APPLICATION NO.	FILING DATE	FIRST NAMED INVENTOR	ATTORNEY DOCKET NO.	CONFIRMATION NO.
09/622,089	08/10/2000	Hiroki Nomoto	490042-87GS0	6664

Office Action Summary

DETAILED ACTION

Note the bed heights of Moss figure 1 below as annotated by the examiner.

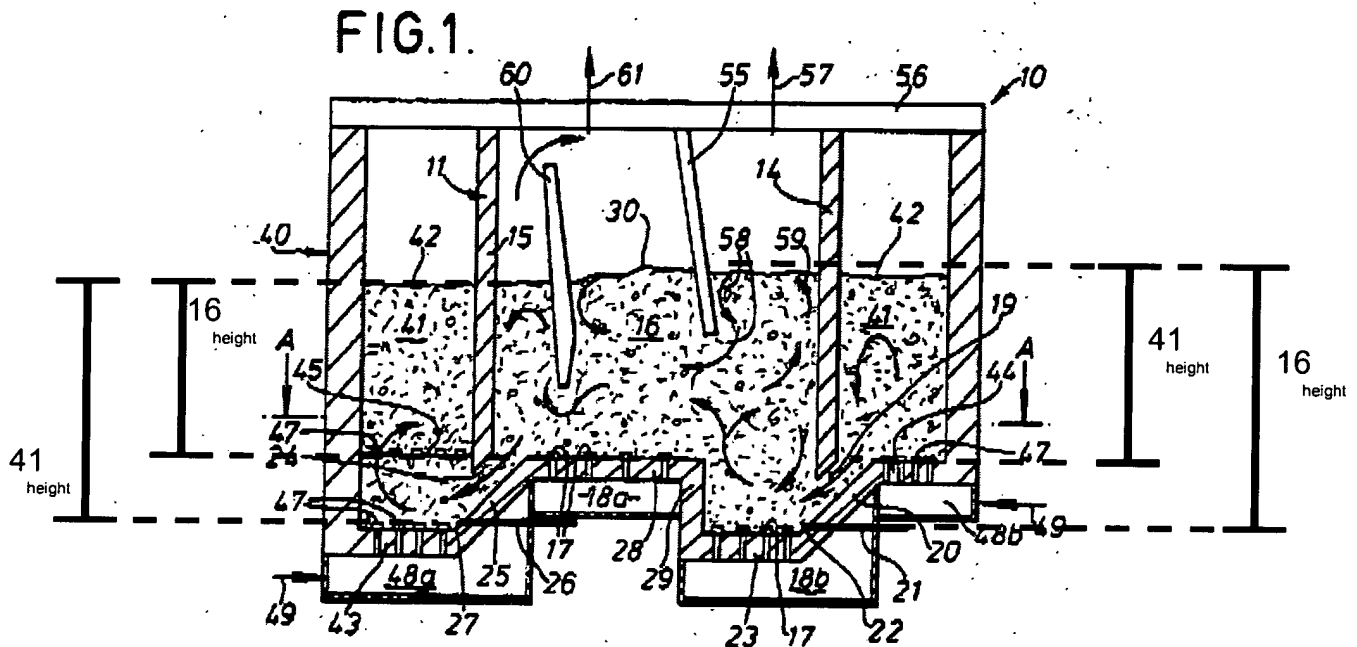
The examiner respectfully disagrees. First, Moss does not explicitly state (and applicant has not pointed out where in Moss it is stated) that back mixing occurs or could occur. Second, even though the Moss states that the bed above the ramp/connecting hole results in flow of material down the ramp to the next compartment

the device, Moss also illustrates wherein the bed heights are different downstream and upstream of the connecting hole.

As annotated above, on the left side of the figure, upstream 16 is a different height than downstream 41 and on the right side of the figure, upstream 41 is a different height than the downstream 16.

The bed heights, in addition to the ramp/connecting hole, would impart some sort of effect upon the flow of material whether is it explicitly stated by Moss or not.

Since the apparatus of Moss continues to meet all of the structural limitations of the claims the rejection is maintained.
